ALTERNATES PACKAGE

NOVEMBER 24, 2025

POMPEY PARK  
DELRAY BEACH, FL

# CITY OF DELRAY BEACH POMPEY PARK REC CENTER

CERTIFICATES OF AUTHORIZATION:  
LB66680  
DES. DNN. CHK.  
PROJECT / FILE NO.  
21-00053  
DRAWING NO.  
H1.4.1  
DATE DRAWN:  
11/20/2025  
APPROVED: BRIAN R. SHORE, PLA  
FLA. REGISTRATION NO. LA6666770  
DATE: 11/21/2025

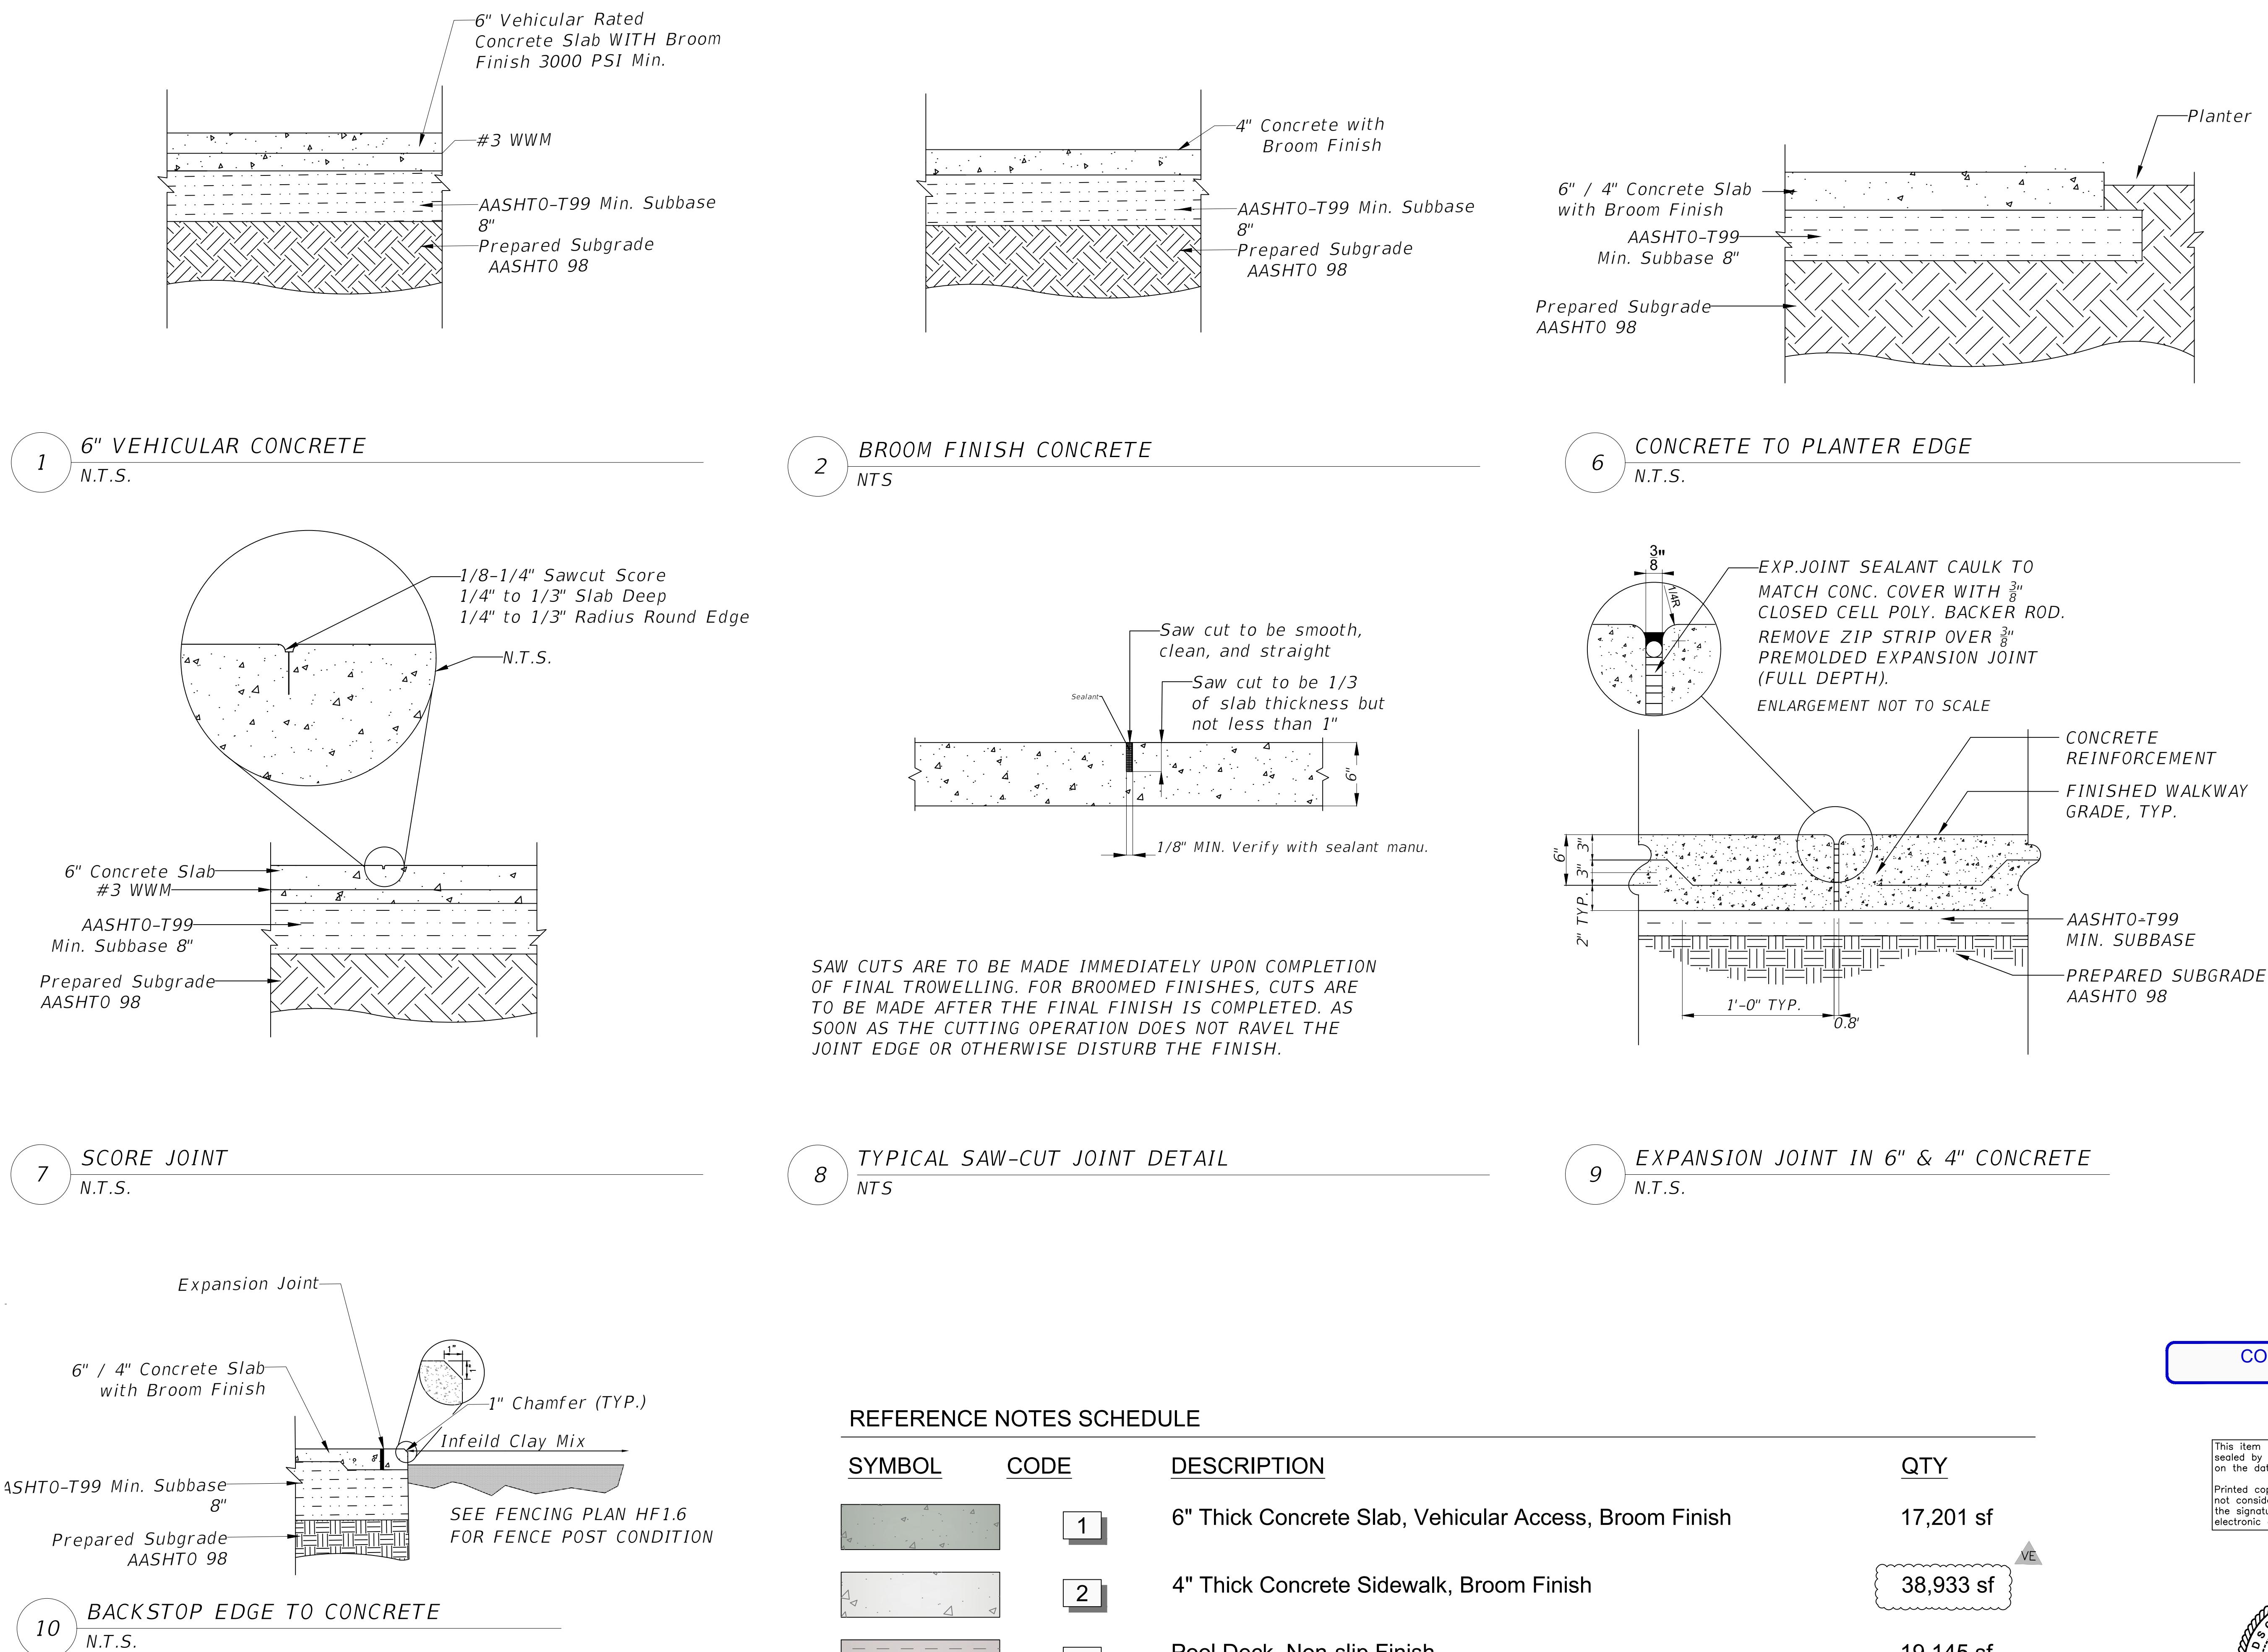
THIS VALUE ENGINEERING PROPOSAL WOULD REPLACE THE 5" THICK SCORED CONCRETE WITH ROCK SALT FINISH LOCATED TO THE SOUTH OF THE BUILDING WITH 4" THICK STANDARD BROOM-FINISH CONCRETE. APPROXIMATELY 10,465 SF OF 5" ROCK SALT-FINISHED CONCRETE (ITEM #4 ON SHEETS H1.4 AND H1.5) WILL BE REPLACED.
